CRANE FARMS
861 20th Ave.
Larned, KS 67550

February 25, 2018

Groundwater flow in the Mystery River drainage area does not flow to Quivira and this area must be removed from all LEMA proposed solutions to the streamflow at Zenith.

Figure 3. Contours of 1991 water elevations for GMD5. Groundwater flow is perpendicular to the contour lines, as shown by the arrows.

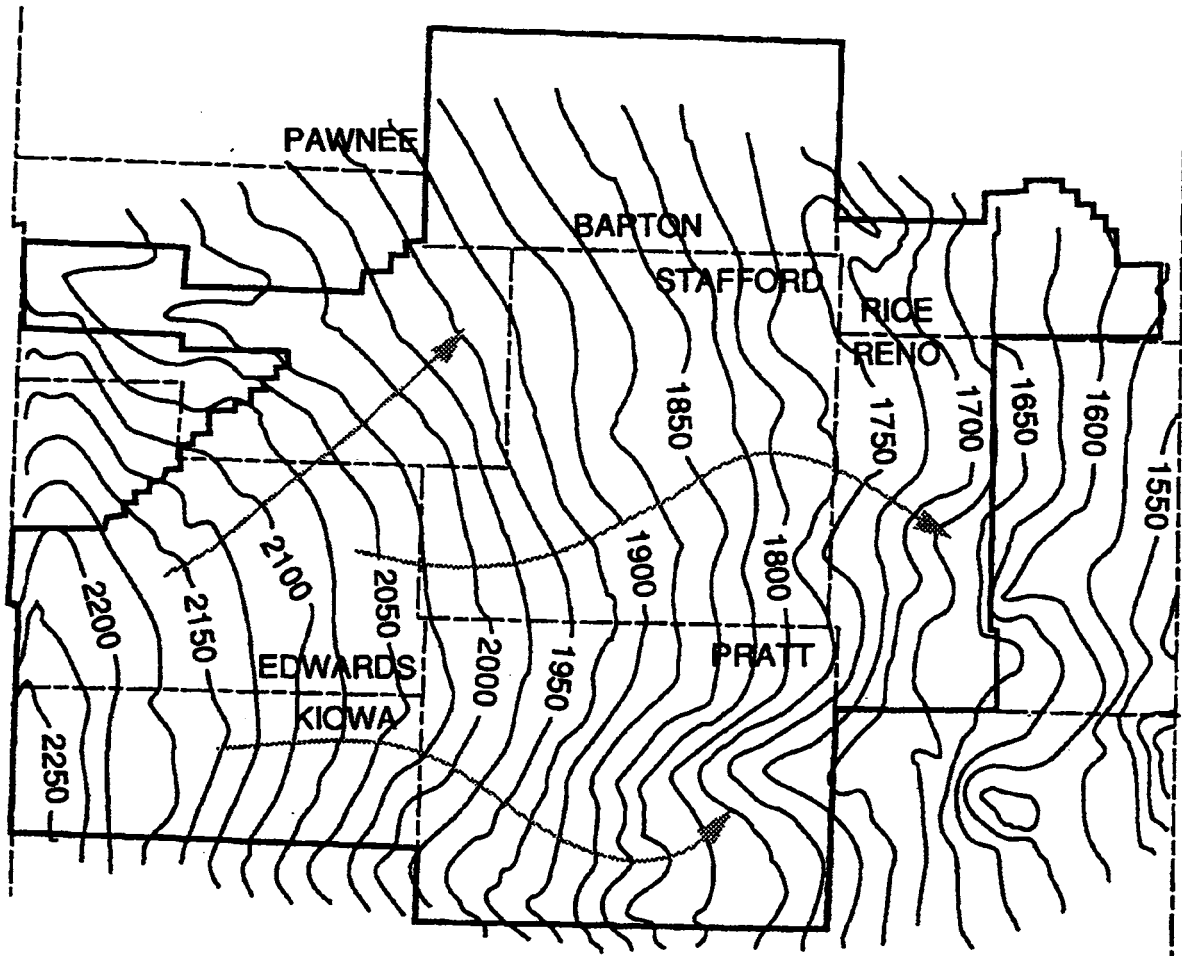
Figure 3 below is from the Kansas Geological Survey Mineral Intrusion Report (http://www.kgs.ku.edu/Hydro/Publications/1992/OFR92_25/OFR92-25.pdf). The illustration indicates that "groundwater flow is perpendicular to the contour lines, as shown by the arrows."

Page 6: "Figure 3 shows our best available estimate of the water table in 1991, with flow lines superimposed on the water elevation contours. The water table slope (or "gradient") and the permeability of the aquifer permit us to estimate the

rate of flow: the linear velocity of a particle of groundwater over much of the area is about 1 foot per day (calculated values range from a few tenths of a foot to several feet per day)."

Figure 16. Water-level surface map with locations of observations for January 2005 . Contour intervals are 30 feet.

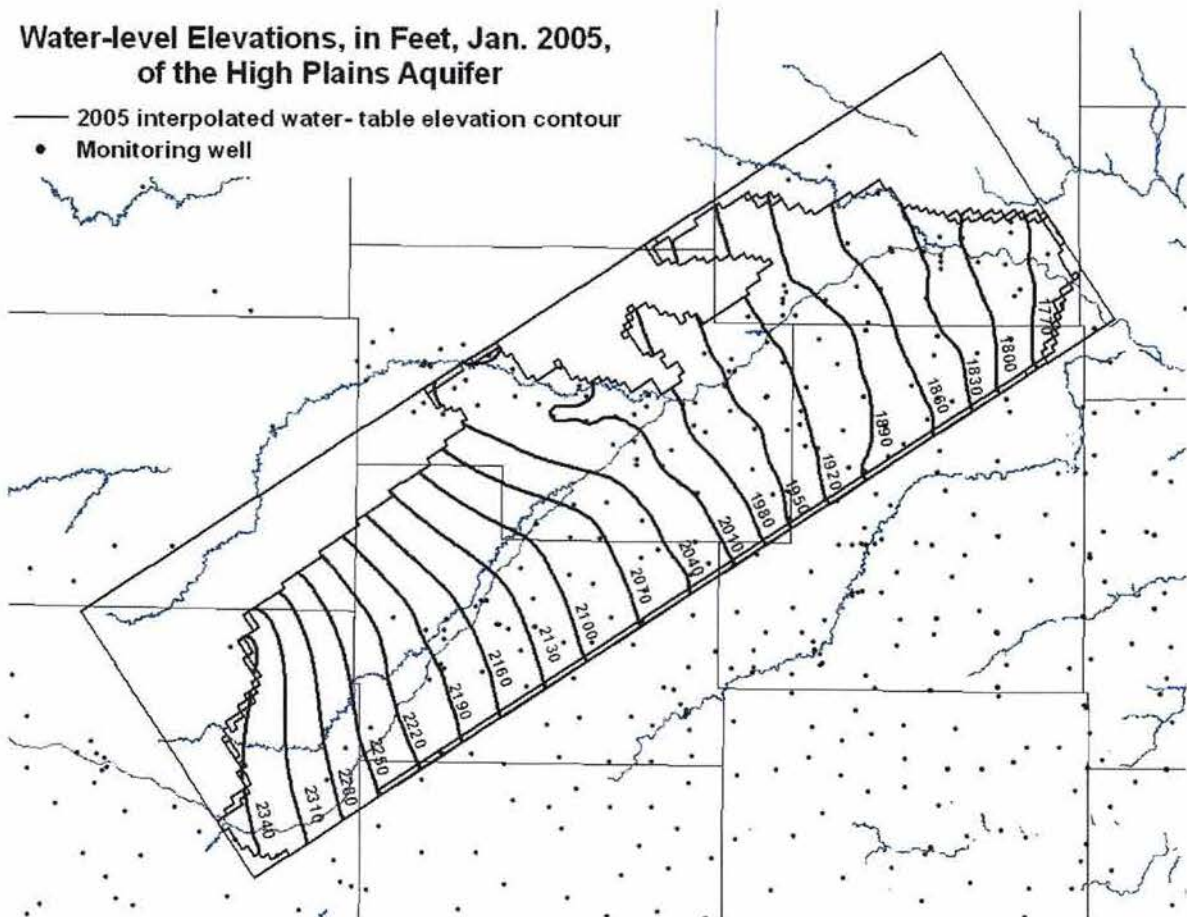
Figure 16 below is from the Kansas Geological Survey Numerical Model of the Middle Arkansas River Subbasin (https://agriculture.ks.gov/docs/default-source/bmt---modeling/mid_ark_final_model_report.pdf?sfvrsn=2). This image reiterates the contour lines and the report states, "the general direction of ground-water flow is from the southwest to the northeast." The water flowing from the Mystery River drainage area does not flow to Zenith/Quivira.

Page 27: "The water-level surface for winter (January) 2005 for the active model area is displayed as a contour map in Figure 16. The general direction of ground-water flow is from the southwest to the northeast."

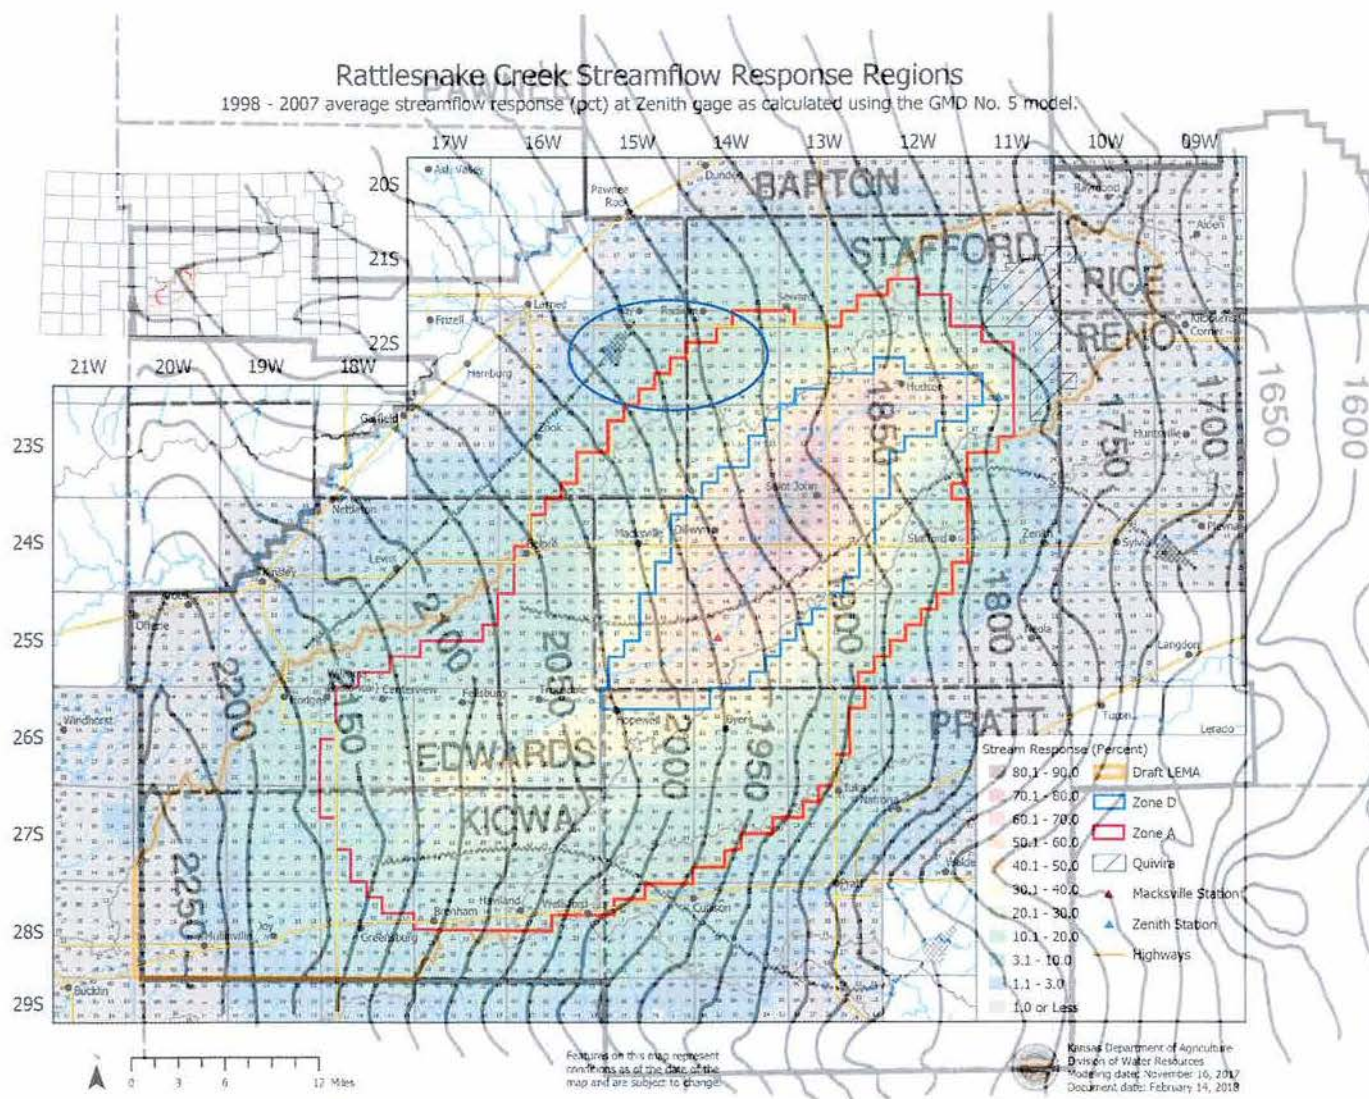
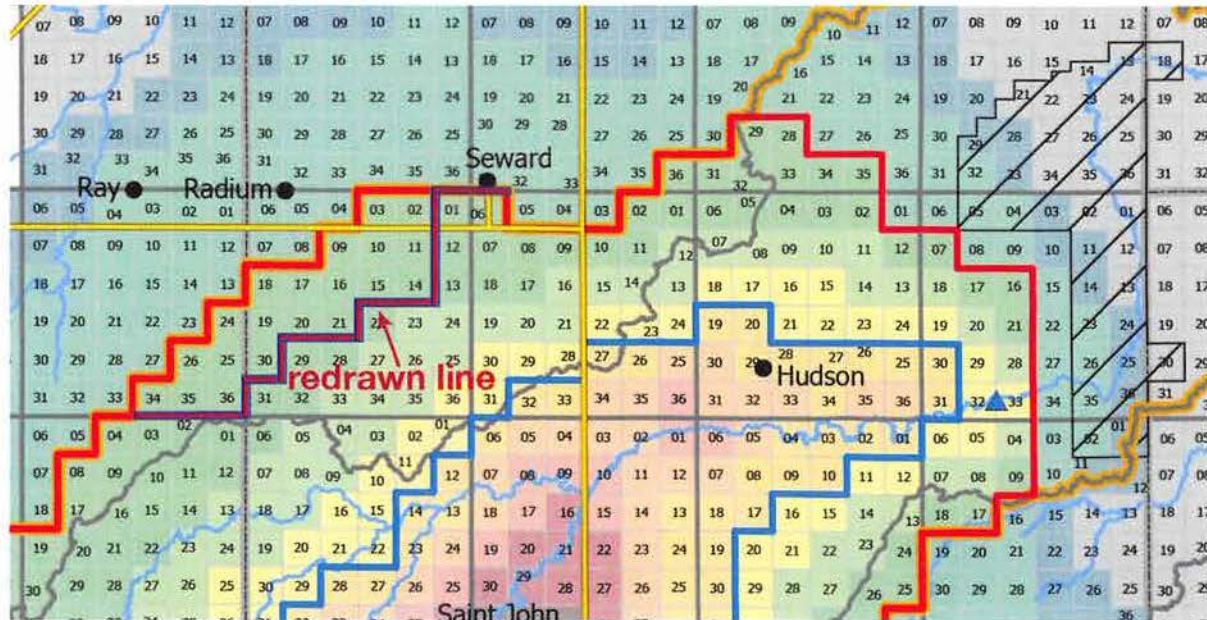
To make this point more clear, we have superimposed the 1992 map with arrows from the Kansas Geological Survey over the LEMA's proposed Response Region map. It is very obvious that the water from the Mystery River area flows north-northeast. While the water may come close to Quivira, it will not actually flow into Quivira nor will it have any impact on the Zenith gage, and therefore it should not be included in the LEMA proposal.

We respectfully request that the lines be moved back to exclude the Mystery River drainage area from the Rattlesnake Creek Streamflow Response Region map and any proposed LEMA action. Please see the map below with the new requested border line.
